Approved 12 6-3  
-H.O.

**Description of Work**  
 SFD/CUSTOM (1\_) STORY HOME, 2 CAR ATTACHED, 3 CAR DETACHED GARAGE, REAR PORCH, 1 STORY, Full Basement, Basement = Partially Finished, 12R, 3FB, 1HB, 1FP, 2 Car Attached, 4BR, Front Porch, ENERGY METHOD = Prescriptive Method, null.

**From:** Oswald Jr, Woodin  
**Sent:** Friday, December 1, 2023 11:04 AM  
**To:** rford@robinfordbuilding.com  
**Subject:** B23004609\_14850 Old Frederick Road\_Floor Plan Question  
**Attachments:** bedroom defintion.pdf

# THE MELTON RESIDENCE

FINISHED BASEMENT PLAN- 1718 SQ.FT.  
SCALE: 1/4"=1'-0"

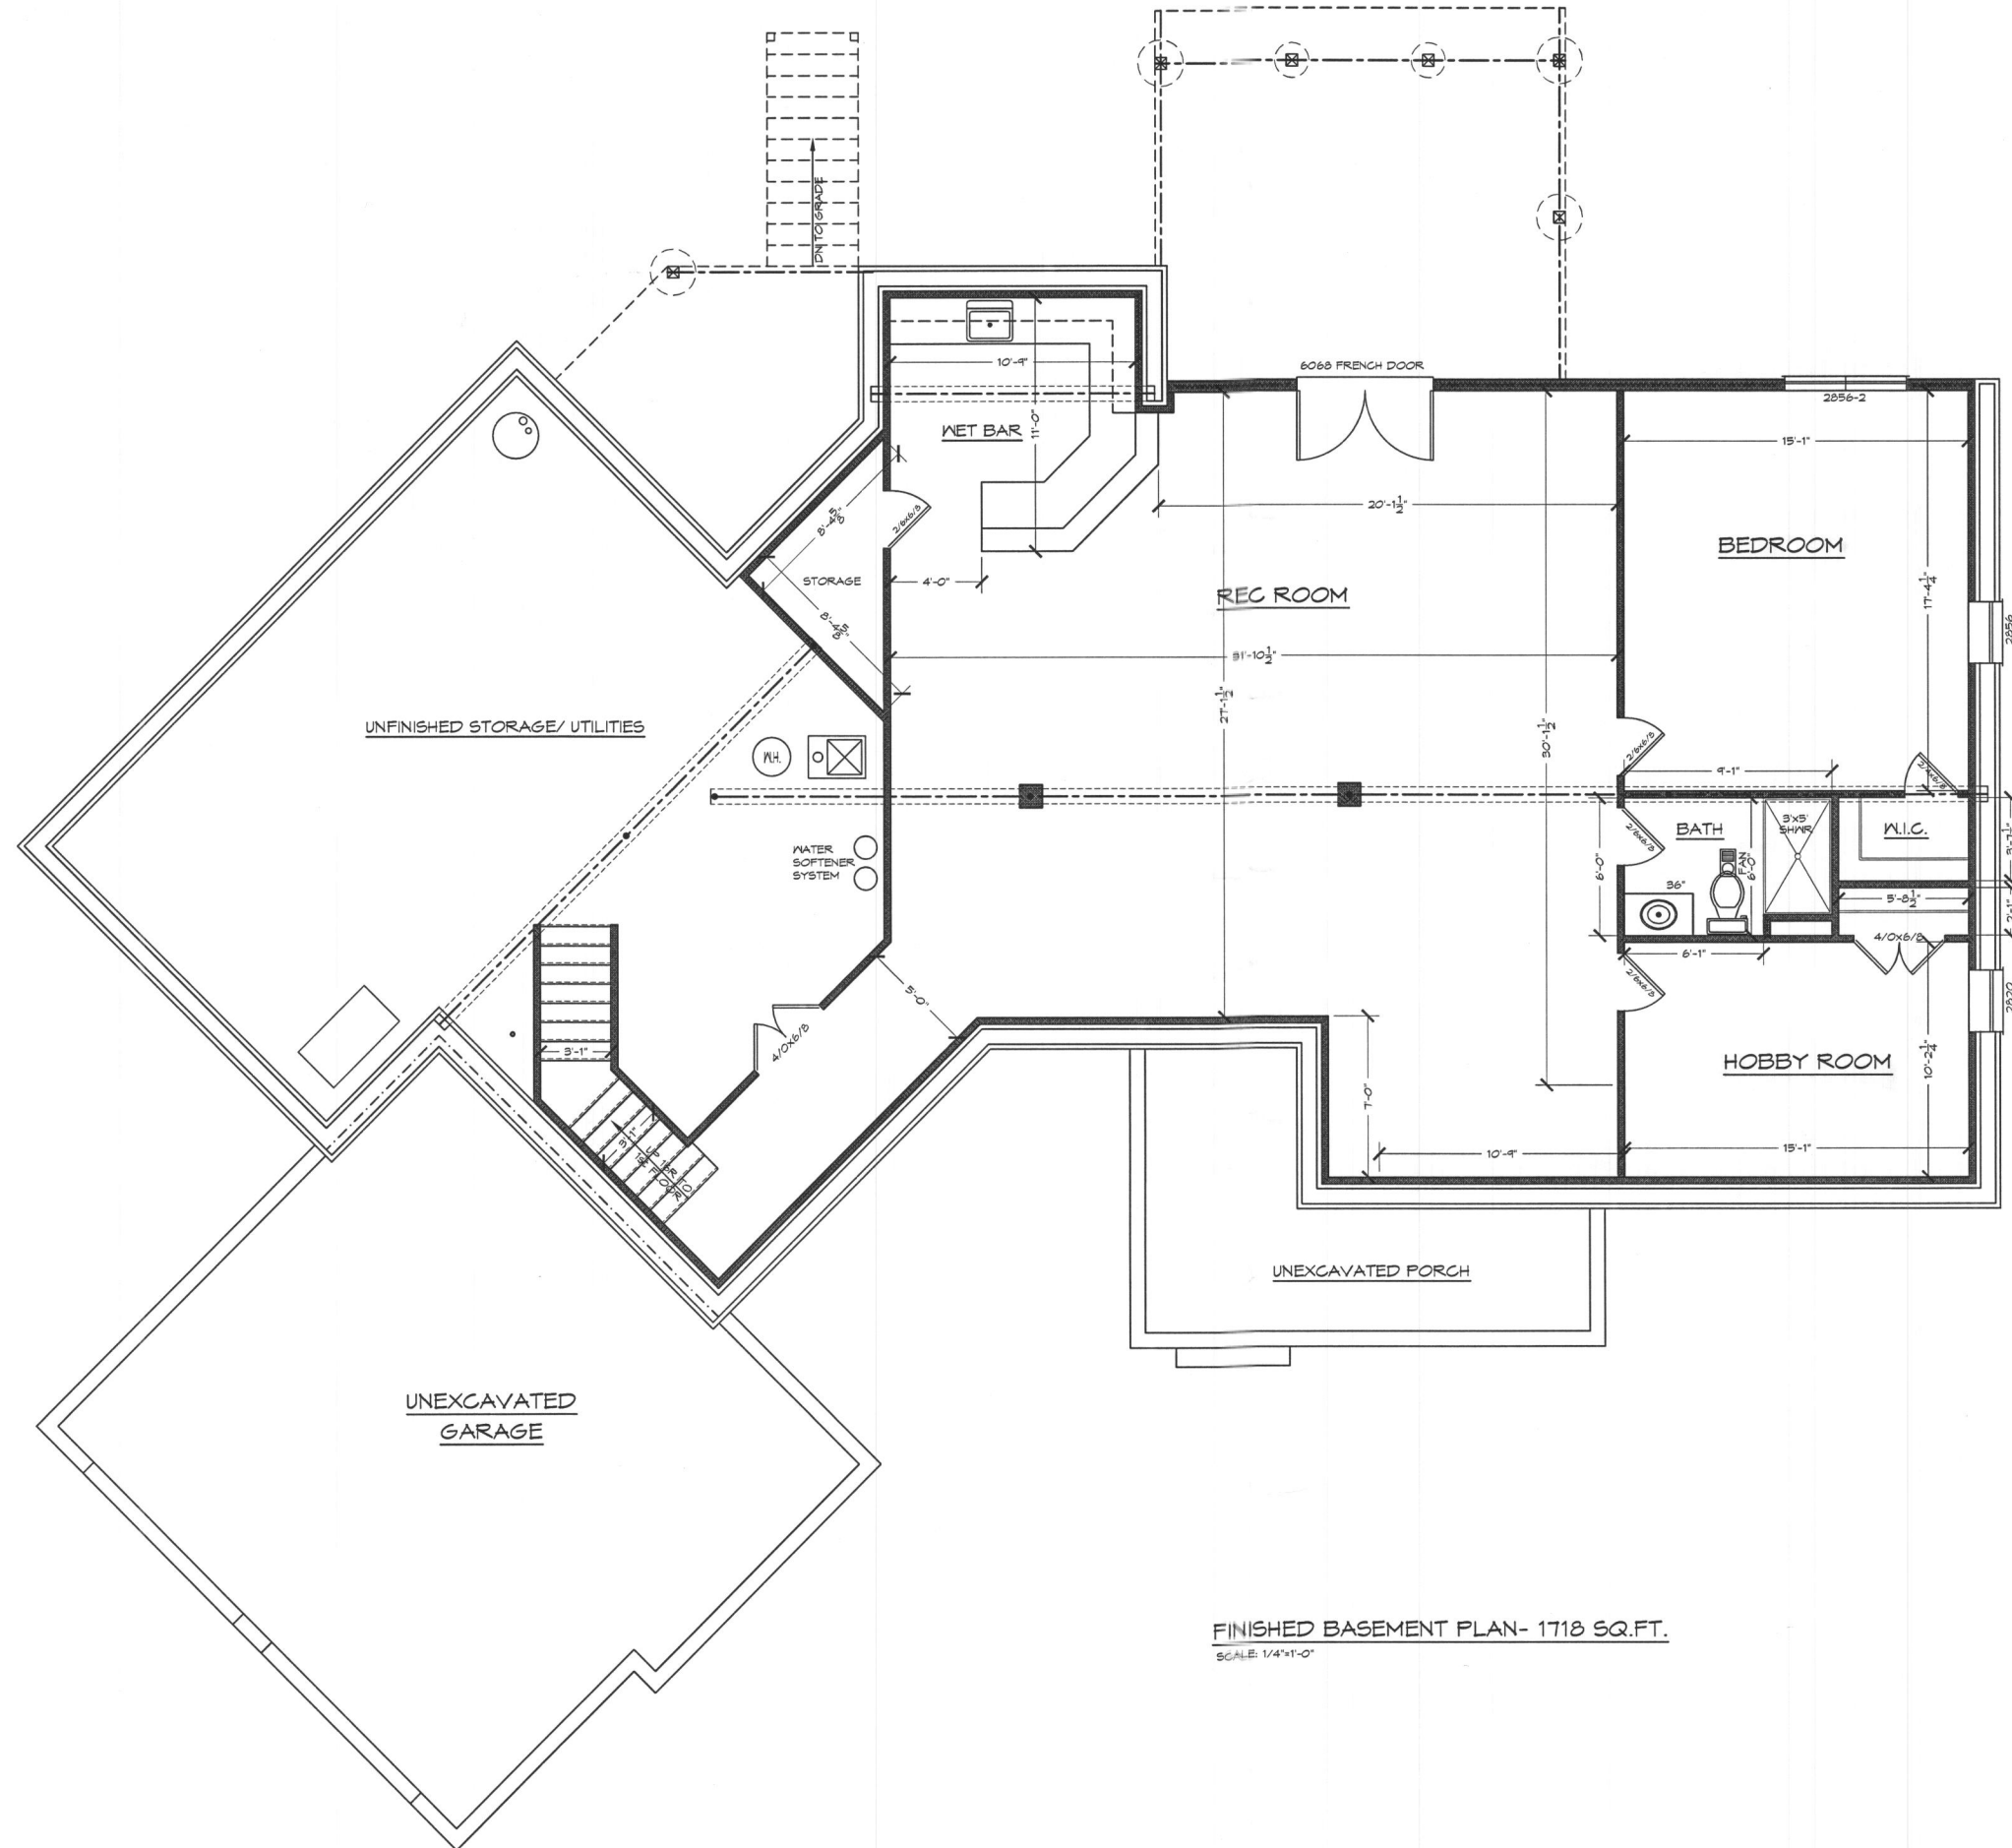
I have a couple of questions regarding the floor plans for 14850 Old Frederick Road. Will the area above the garage be finished living space? Does the garage have plumbing? Does the hobby room in the basement have any kind of window? If it does, it meets the definition of a bedroom under local code.

As it stands, I am seeing 5 bedrooms; 3 on the first floor and 2 bedrooms in the basement. I just want to make sure the # of bedrooms don't exceed the design of the septic system which is for 5 bedrooms.

Good afternoon. Thanks for getting back to me with these details. The definition of a bedroom (see attached) doesn't specify type of window, so it can be any size window. With that said, the Hobby room would count as a bedroom under this definition. Since the floor plan shows 5 bedrooms, and the septic system was designed for 5 bedrooms, the building permit can be approved. Thanks again for your time.

Sorry took me a bit to answer your questions 1. Area over garage is for storage it is not finished in any way . No insulation , no drywall , no plumbing . Will just have one light . No future finish 2. Hobby room in basement has a 32"

wide by 20" high hopper window . Doesn't meet egress . Wasn't intended to be bedroom , it's intent is hobby craft room  
3. We have it as three bed up and one in basement . But not sure how you all recognize the hobby room .
